Site Plan Review Application
Subsequent Materials & Updated
Information
to the
City of Belfast

Convenient MD
Belfast, Maine

RE: Response to Questions/ Materials for Belfast Convenient MD – Site Plan Application

Sign Plan

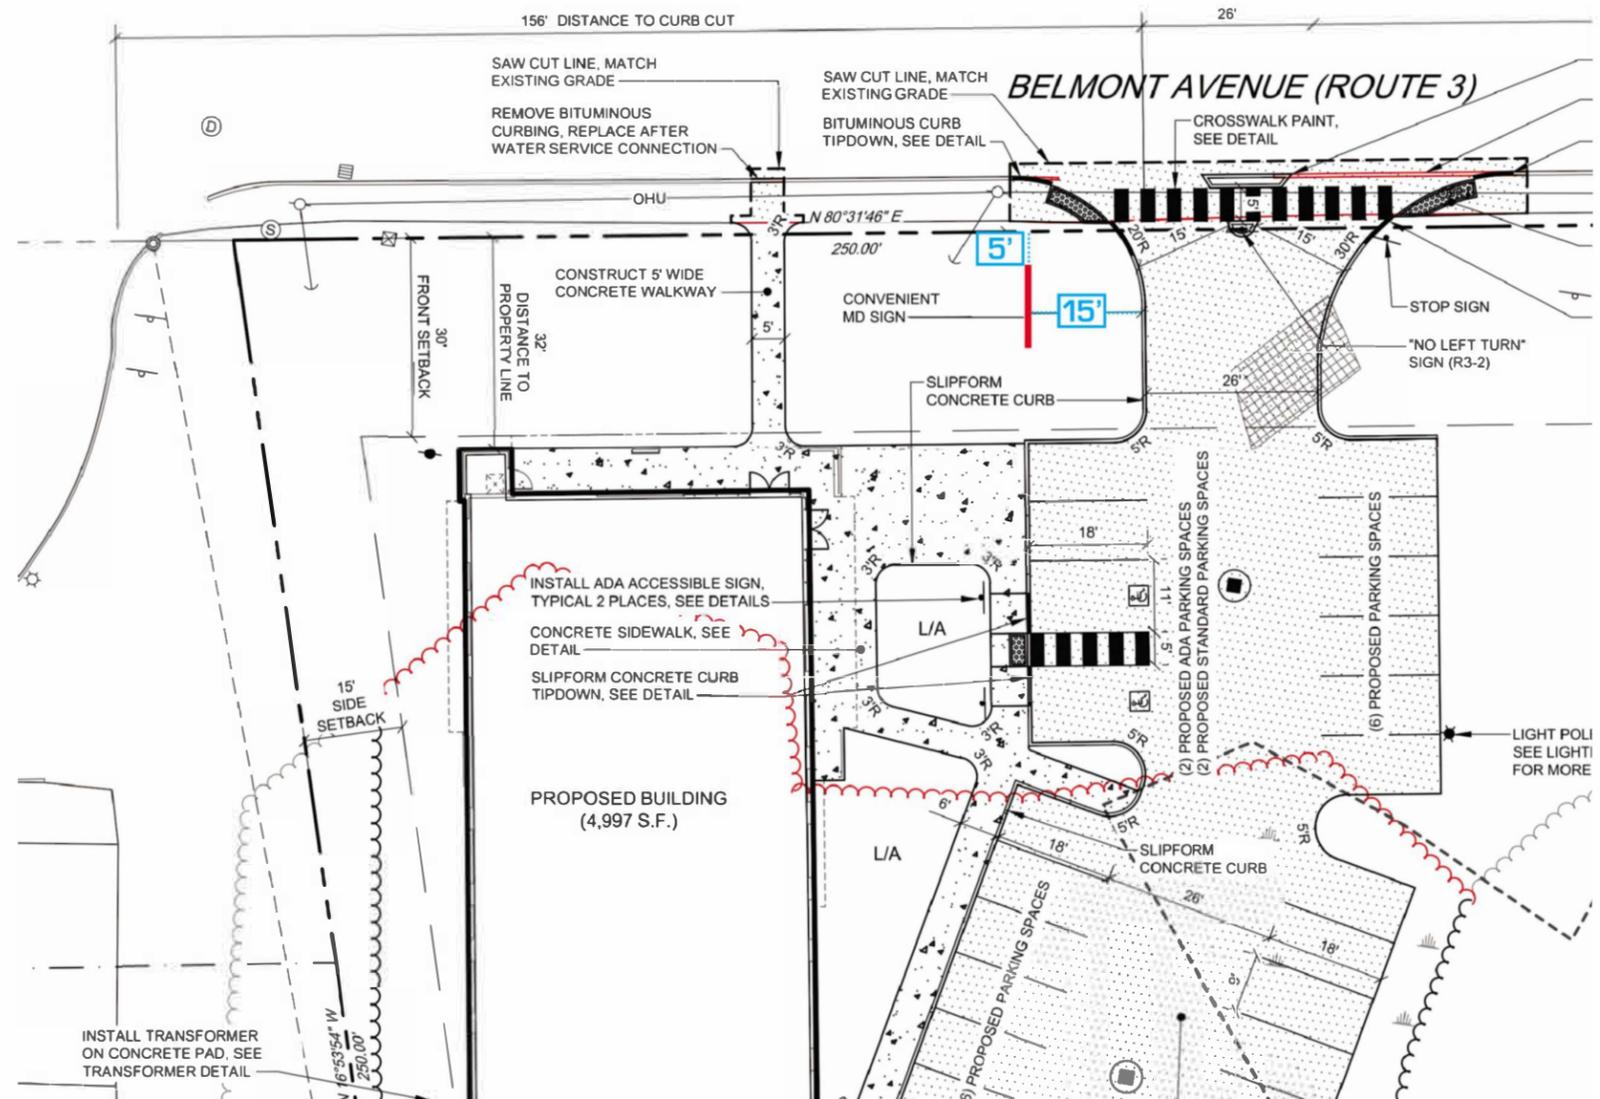
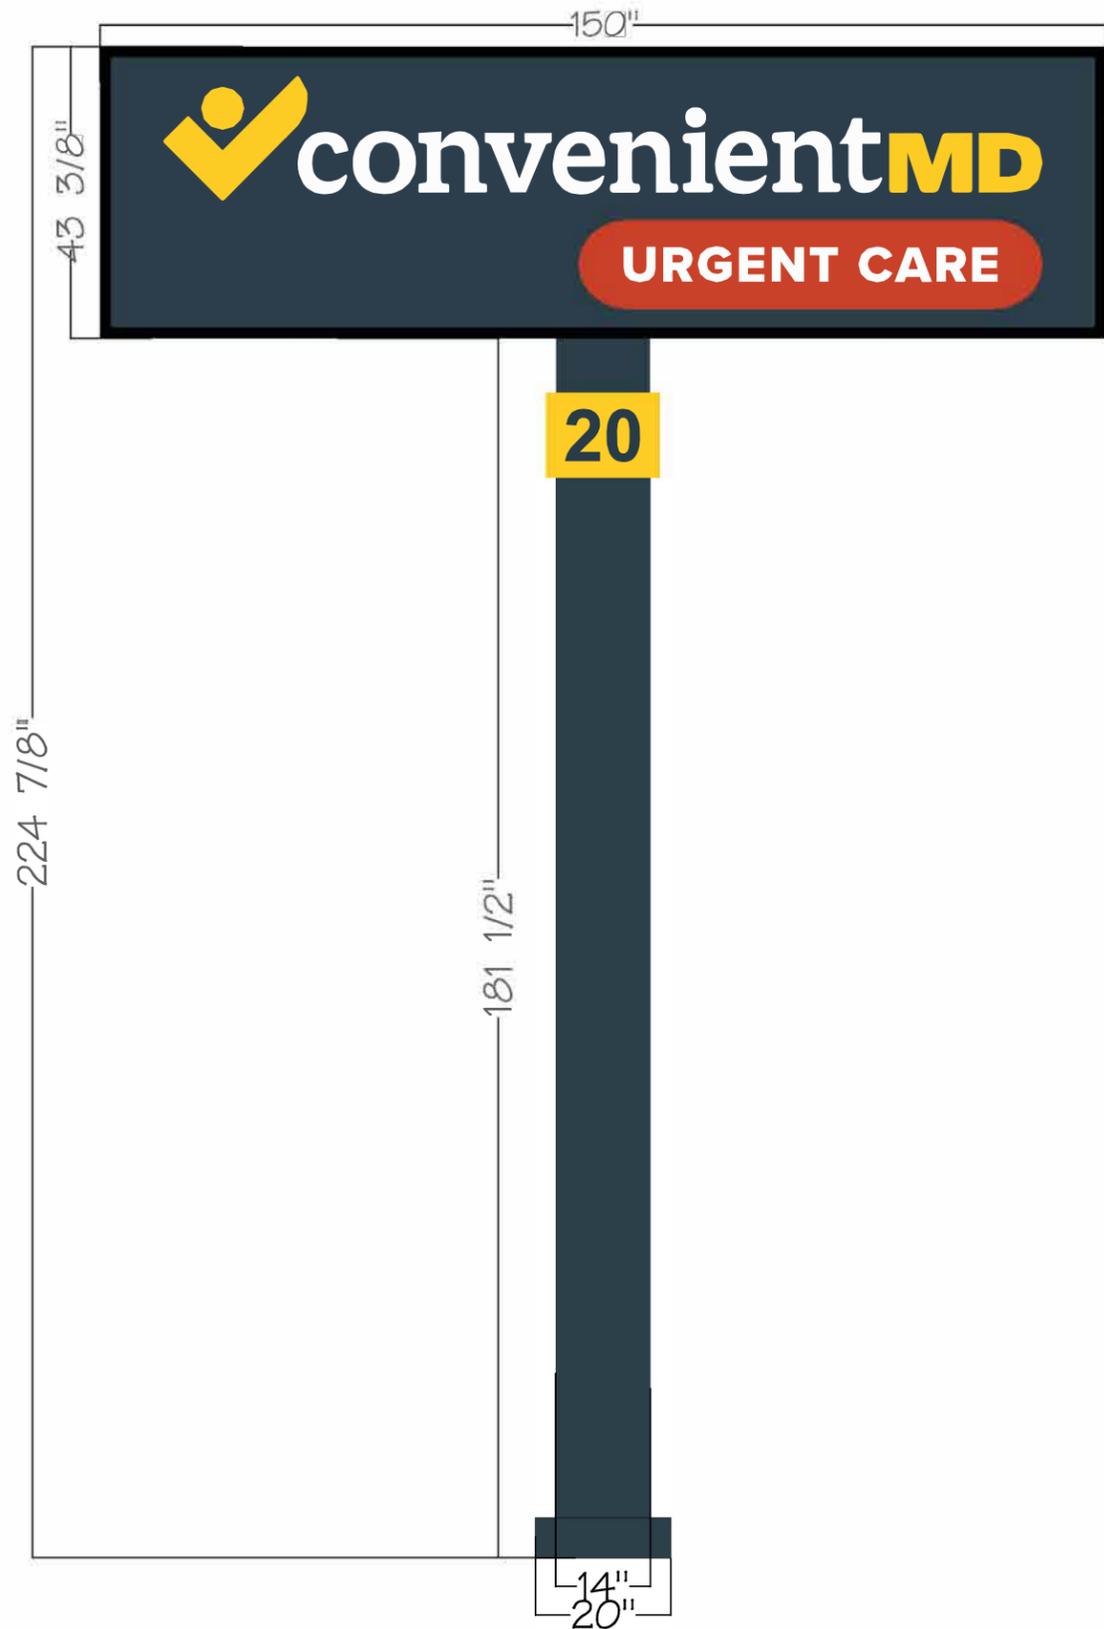
Signage: I have concerns that your proposed signage does not meet the size requirements for the Route 3 Commercial zoning district. You will need to work with the CEO, as the planning board does not review signs.

Response: The applicant will work with the CEO, as noted.

Lighting Photometric Plan

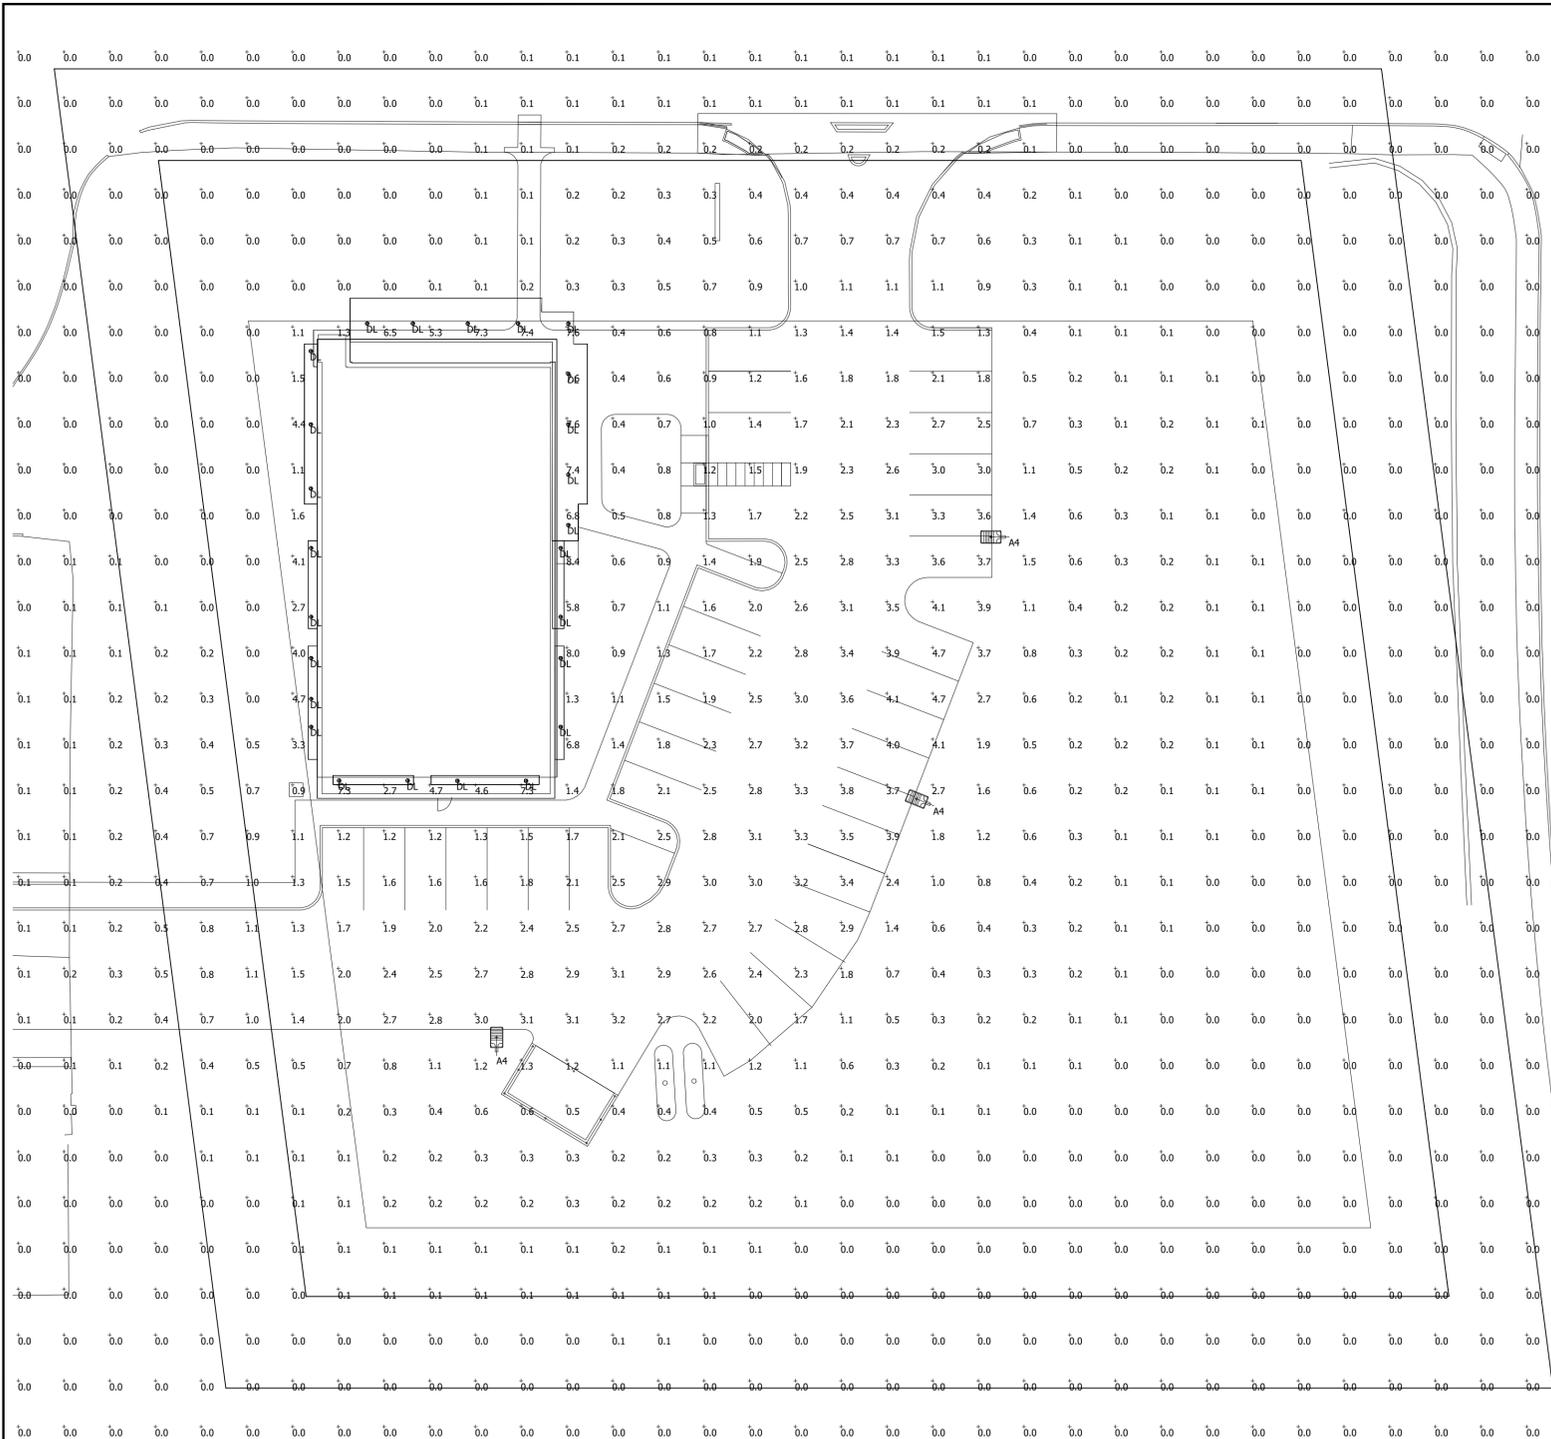
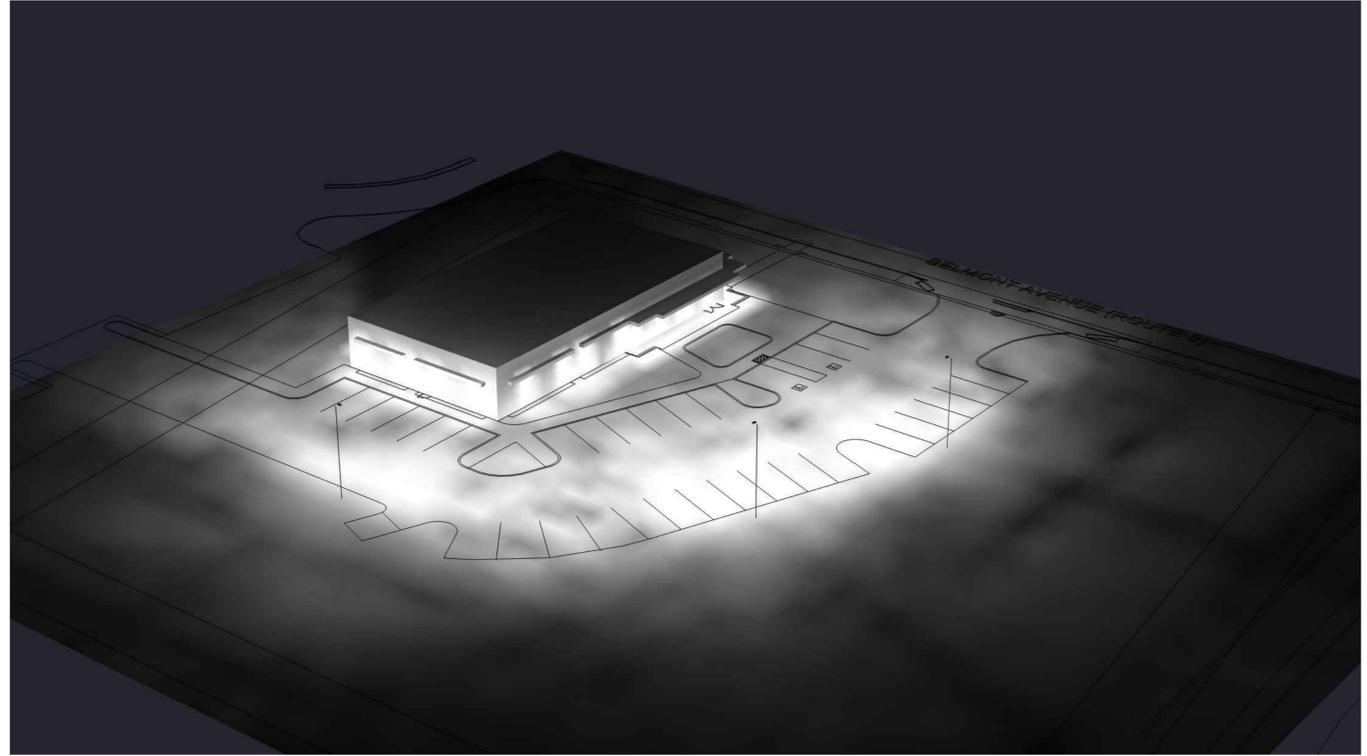
Lighting: Your application identifies the types of lights you plan to use. It does not include the number of lights on the building and does not provide a photometric plan that identifies the distribution of light on the site. Without the photometric plan, the Board does not have enough information to make a determination on glare.

Response: Please see the attached photometric plan. The plan has been updated to reflect the adjusted building location. Cut sheets for the fixtures were previously submitted and remain unchanged.

PROPOSED CONDITIONS STORMWATER PLAN
 OF:
BELFAST CONVENIENT MD
 BELMONT AVE
 BELFAST, MAINE
 FOR:
PARKINGWAY MANAGEMENT, LLC
 P.O. BOX 963
 PORTLAND, MAINE 04104

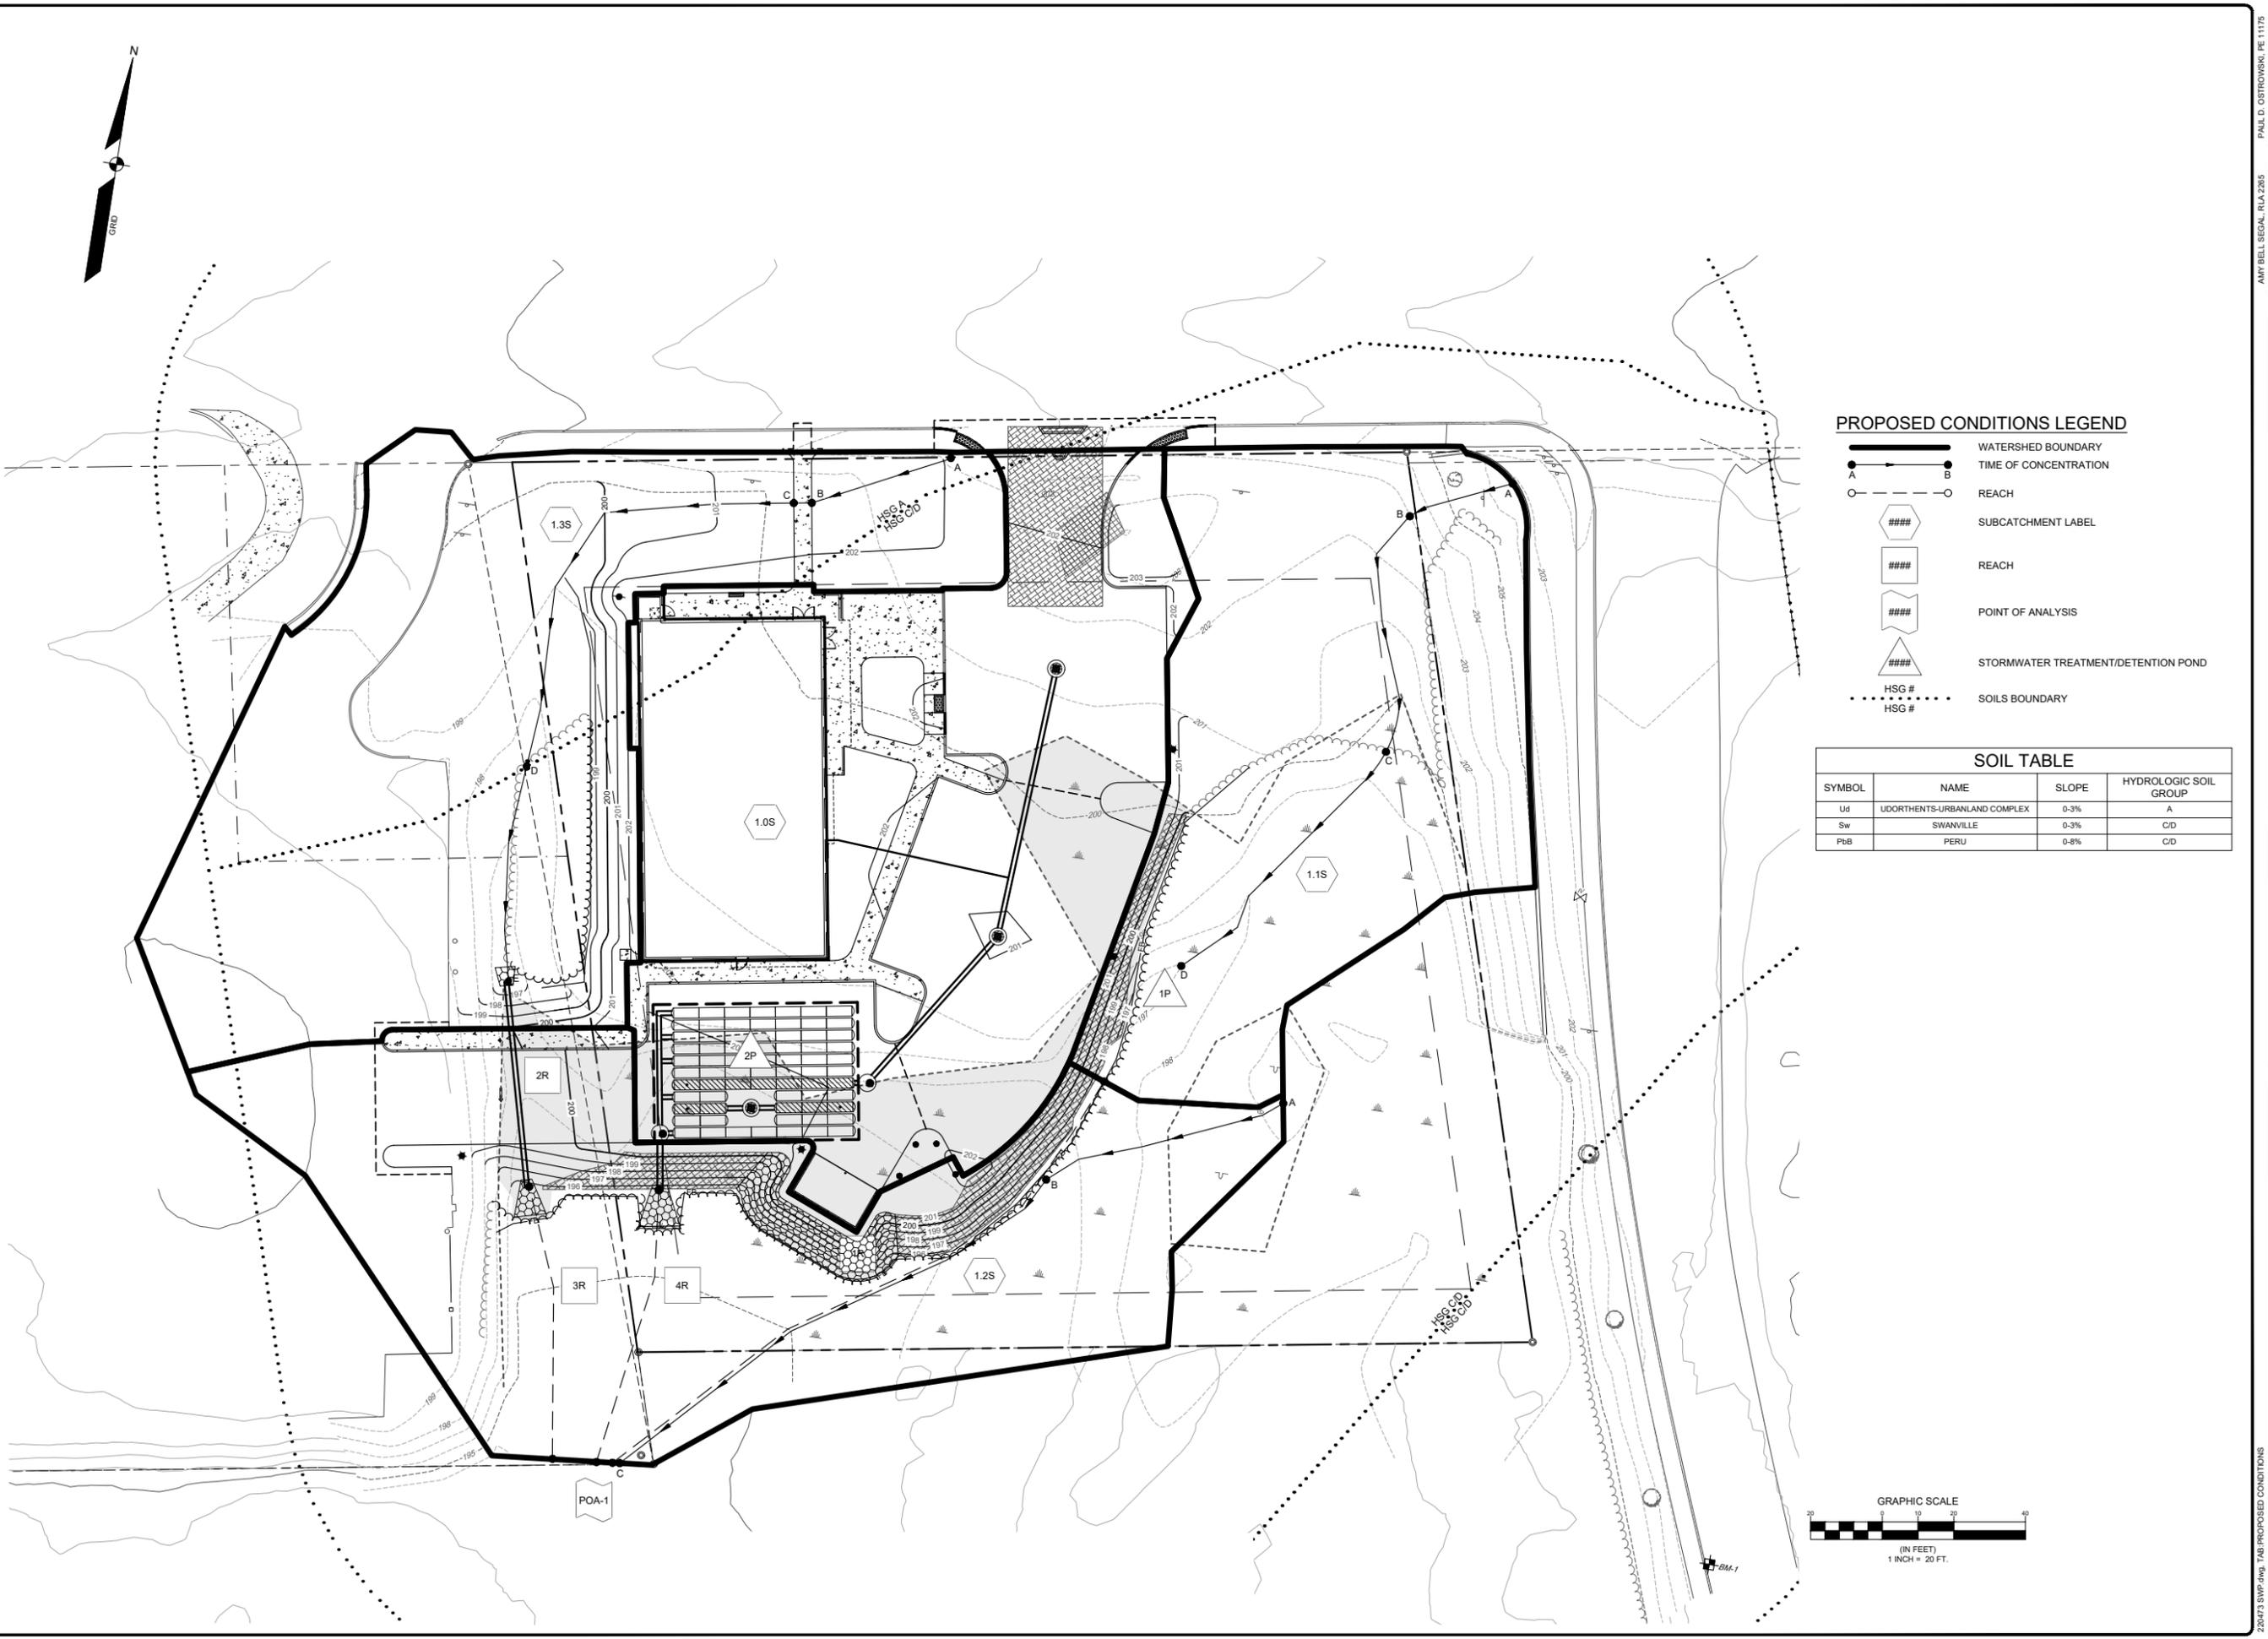
Stormwater: My concern with stormwater stems from the fact that the City has two standards for stormwater. Chapter 98 identifies 2 and 25 year storm events, while Sec. 102-1124 requires a stormwater design that meets the requirements for a 50 year storm. The application is silent with the 50 year storm event. Once I have this update, I will forward your proposed stormwater plan to the City Engineer.

Response: The stormwater requirement mentioned within sec. 102-1124 does not apply to our project as we are located within the Route 3 Commercial District. Planning staff has confirmed this understanding.
